Re: **Stakeholder Comments on Letter of Notice for Additional Feedback from Stakeholder Consultation Session 2 on the Operating Reserve Market Review ("Operating Reserve Market Review")**

The Alberta Electric System Operator ("AESO") received comments from Stakeholders in response to its April 12, 2022 *Letter of Notice for Additional Feedback from Stakeholder Consultation Session 2 on the Operating Reserve Market Review*. These comments have been posted on the AESO website.

Figure 29: Dispatched contingency reserve directed by size  
 (Jan. 2020 to Dec. 2021)

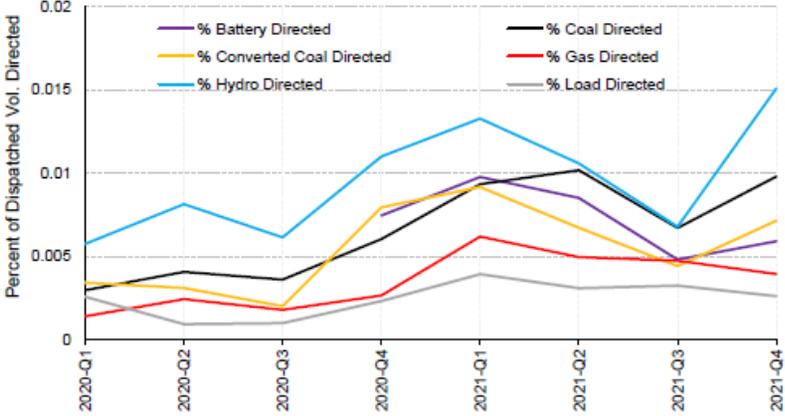
**The historical data on directive rates clearly demonstrates that there are significant differences between the products provided by large and small providers**

The AESO’s “directives are most frequently issued to contingency reserves resources that are larger”.<sup>3</sup> The directive rates for large resources appear to be up to 6-13 times higher than small resources.
